Clinch River Nuclear Site
NRC Docket No. 52-047

Subject: Submittal of Supplemental Information Related to Emergency Planning
Correspondence Between Tennessee Emergency Management Agency and
Tennessee Valley Authority in Support of Early Site Permit Application for
Clinch River Nuclear Site

Supplemental Information Related to Emergency Planning Correspondence Between
TEMA and TVA

Description of the Clinch River 2-Mile EPZ

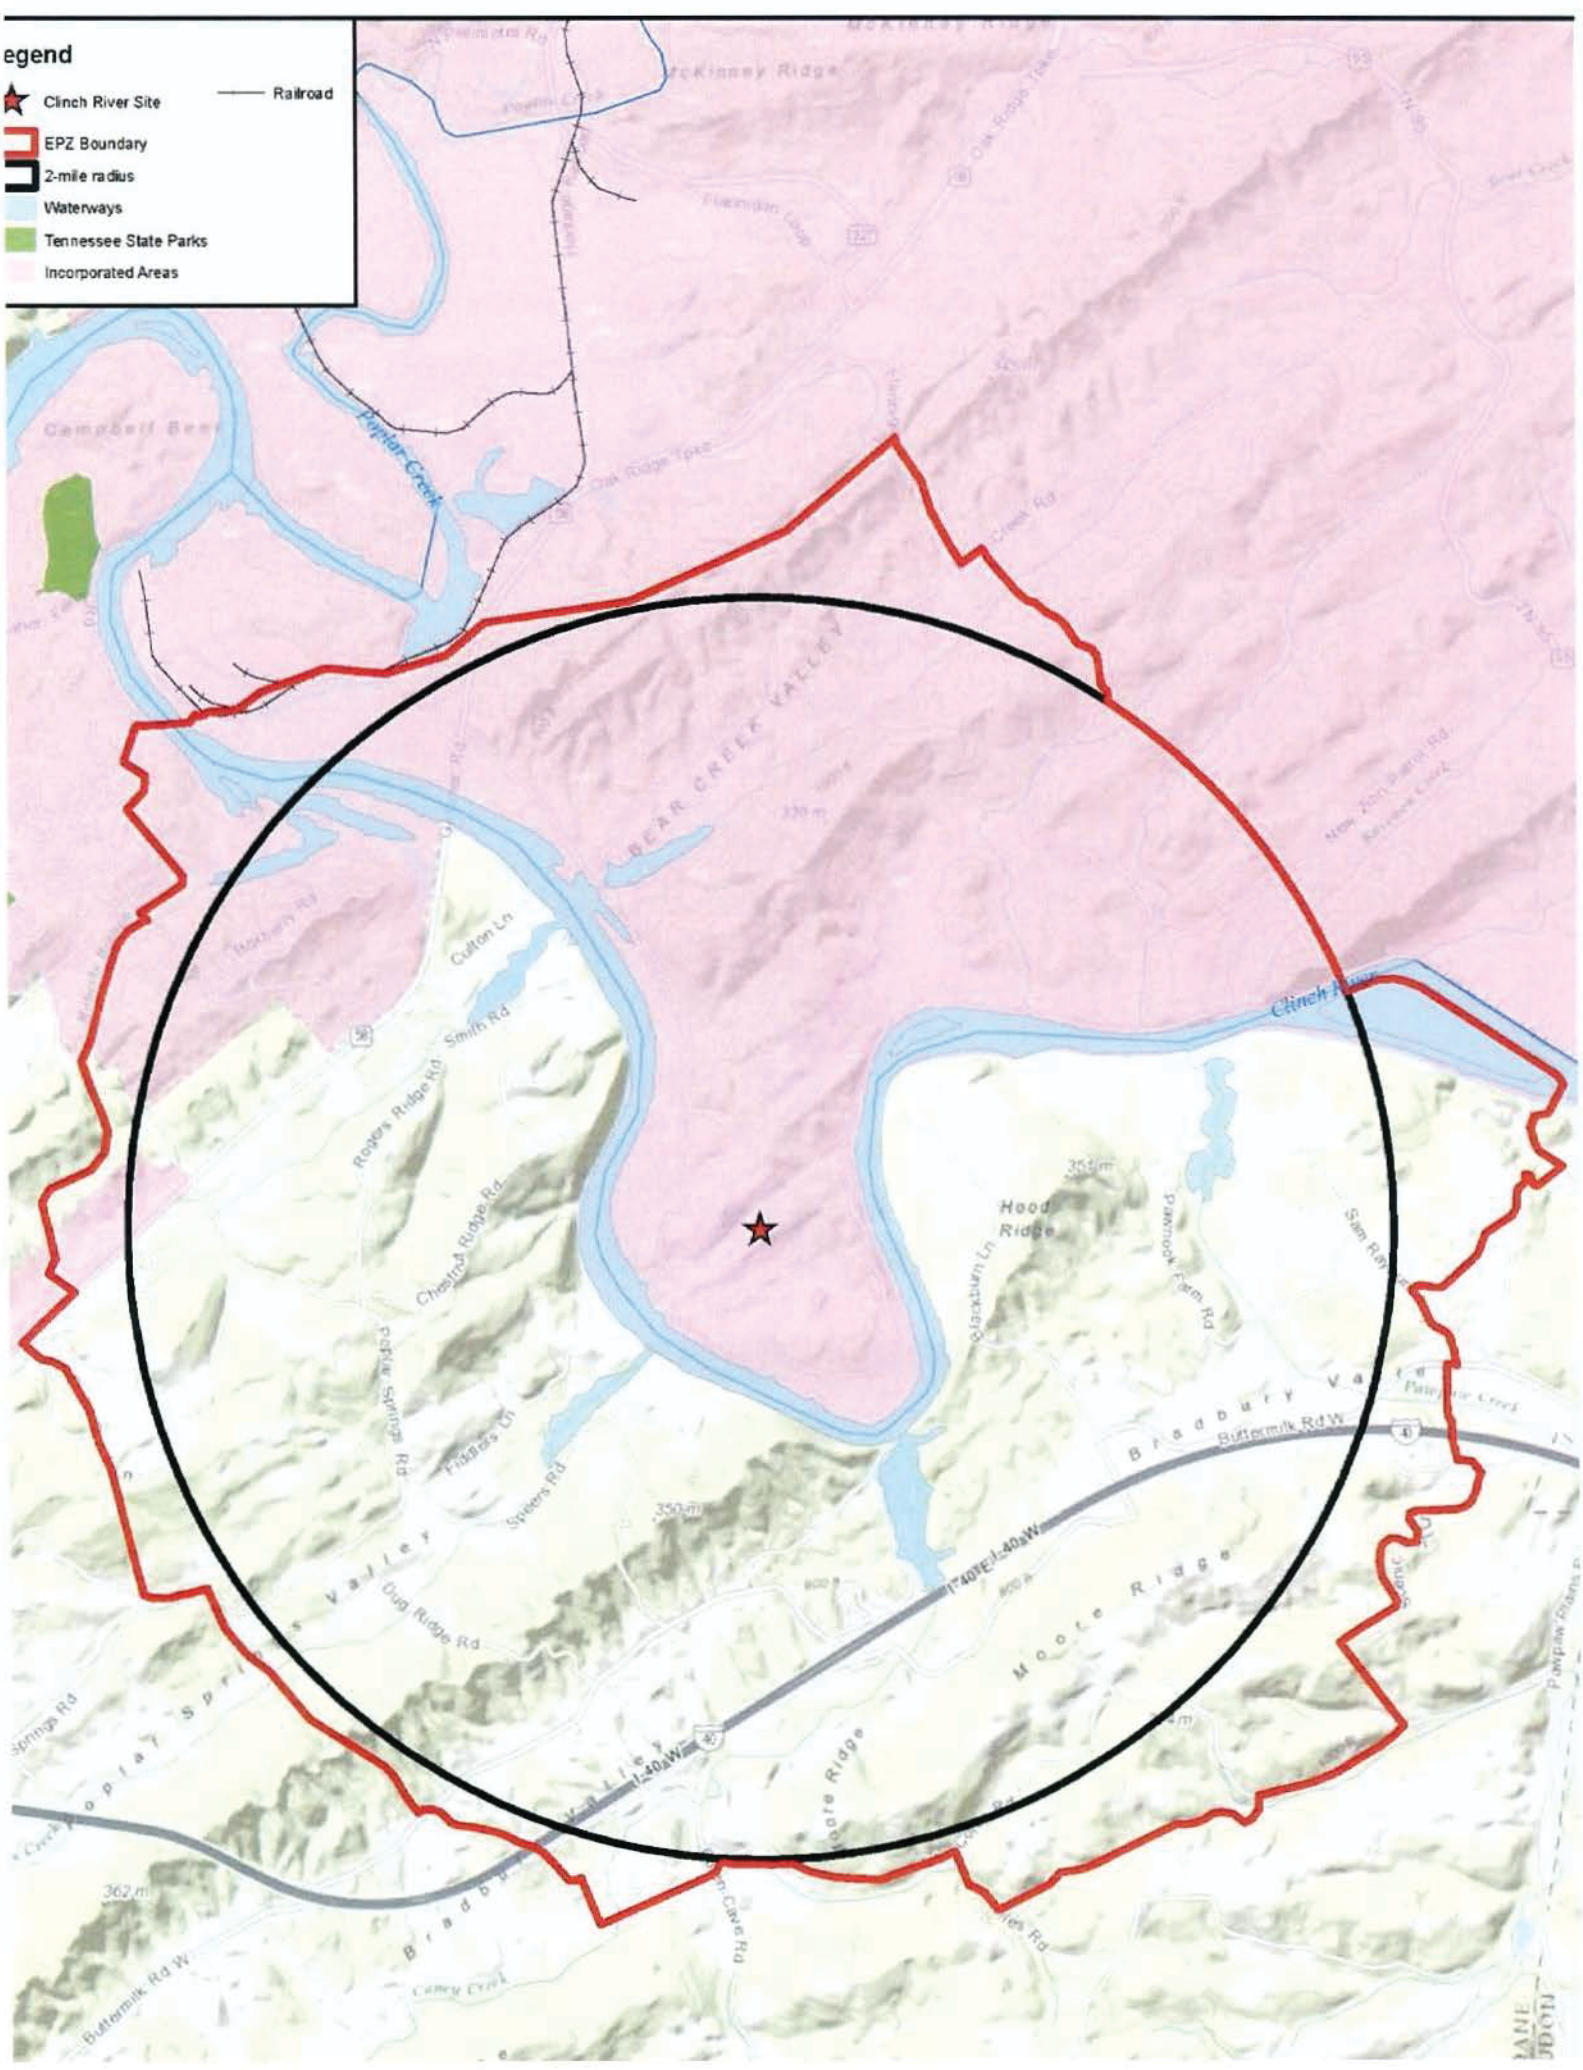
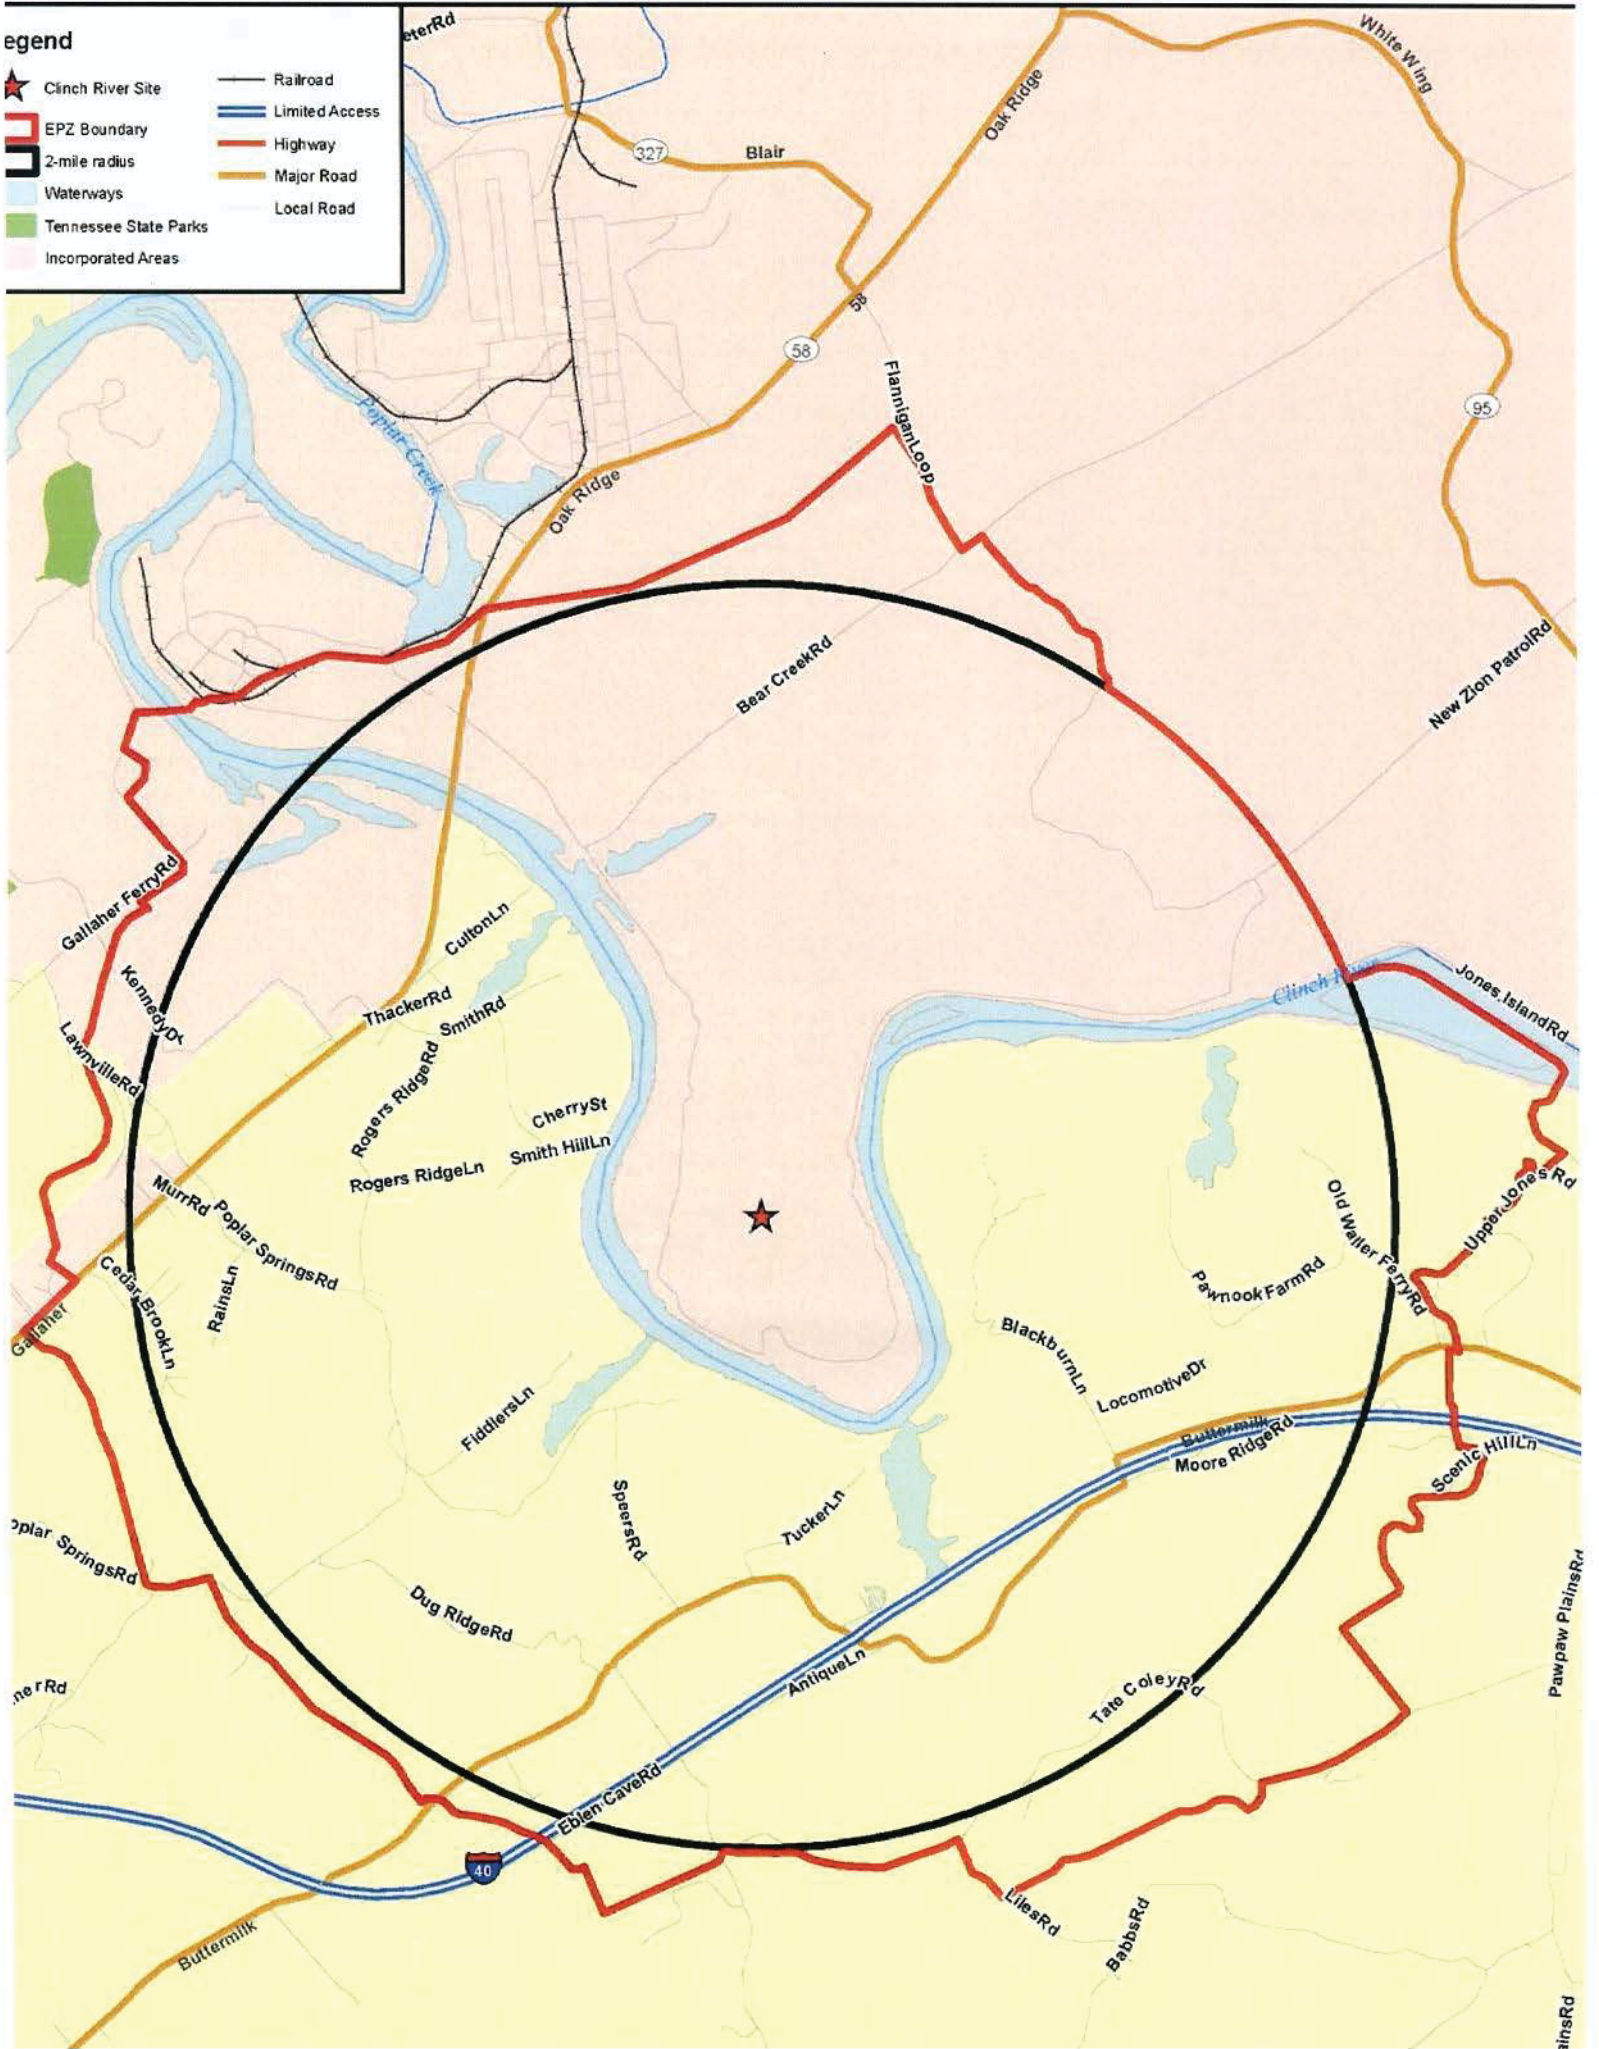
17, 2014 S.H.
On December 12, 2015, staff from the Tennessee Emergency Management Agency (TEMA) participated via conference call in the public presentation by the Nuclear Energy Institute and TVA to the Nuclear Regulatory Commission (NRC) staff regarding the proposed SMR mentioned above. At the conclusion of this presentation, the NRC staff made the determination that it was not given sufficient information to make a recommendation to the NRC regarding the appropriateness of a fence line or 2 mile EPZ. TEMA must concur with the NRC staff at this time that a determination of the EPZ for this proposed project is premature, given the lack of specific information on the nature and design of the proposed SMRs.

Specifically, information regarding the source term of the fuel for the SMRs needs to be identified. Additionally, specific information on the SMR's design and passive safety systems must be made available for review before any EPZ recommendation can be supported. We also concur with Roane County that an Emergency Alert System which is compatible with the system used by the Department of Energy is needed. Until these and other technical questions have been addressed, sufficient information is simply not available to make a determination regarding the appropriate EPZ for this proposed project.

TEMA will remain a strong supporter of this project and will gladly voice this support to the NRC. However, until more complete technical information is available and the Draft Evacuation Time Estimate study is reviewed, we are not in a position to comment one way or another regarding the appropriate EPZ for the project.
